Areas of Specific Concern in the NIST WTC Reports

Below is a series of twenty-five provable points which clearly demonstrate that the reports produced by the National Institute of Standards and Technology (NIST) on the destruction of the World Trade Center (WTC) were unscientific and fraudulent. Therefore NIST itself – including its lead authors, Shyam Sunder and John Gross - should be investigated.

Figure 4-62. Exterior buckling after global collapse initiation.

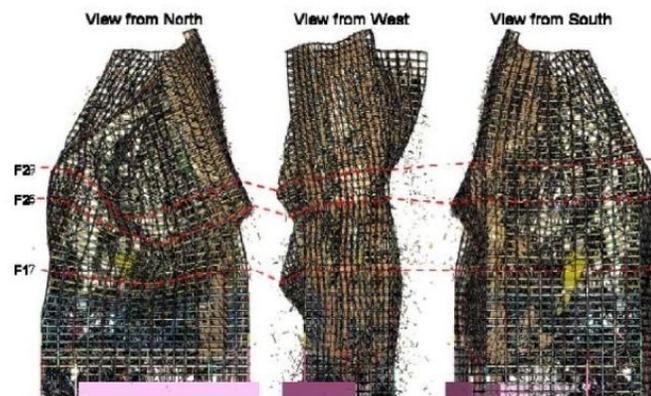
Technical Statement: The exterior of the NIST WTC 7 computer model shows large deformations, as would be expected in a natural collapse, which are not observed in the video of the actual event. There is no attempt in the report to explain this discrepancy.

In footage of the actual collapse, the west penthouse of WTC 7, which spans nearly half the length of the roof, starts to fall one-half of a second prior to the full exterior collapse, yet the NIST report claims that the entire interior failed and completely collapsed prior to the exterior shell collapsing. Since there was little-to-no visible deformation of the exterior in the actual collapse and since the west penthouse collapse timing indicates near-simultaneous interior and exterior failure, it seems clear that the severe deformation of the building’s exterior in the NIST model shows that their model does not replicate the actual

collapse situation at all. The west penthouse drop starting just prior to that of the exterior is also indicative of controlled demolition, where the interior columns are severed just a fraction of a second prior to the exterior, in order to create an inward pull on the exterior and keep the debris contained within the building's footprint.

- Two velocity charts below

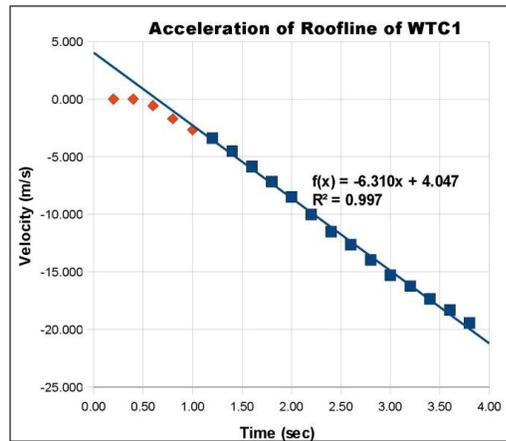
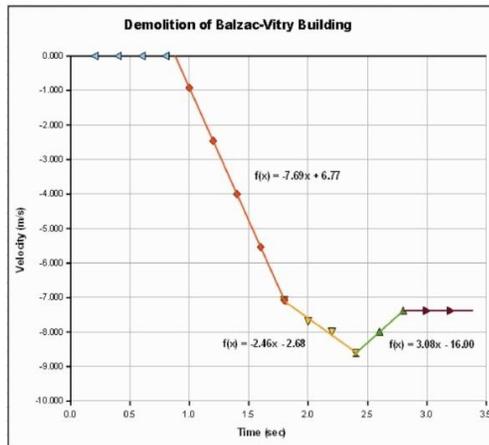
The velocity graphs of the upper sections of both a building demolished by the Verinage technique and that of WTC 1 are shown below. Note the abrupt reduction of velocity in the *natural* force collapse using the Verinage demolition method on the Balzac-Vitry building in France vs the *continuous* acceleration of WTC 1. The columns in WTC 1 must have been “removed” prior to impact. This can only be done by explosives — for which there is abundant evidence, as outlined in the documentary film, *9/11: Explosive Evidence—Experts Speak Out*.
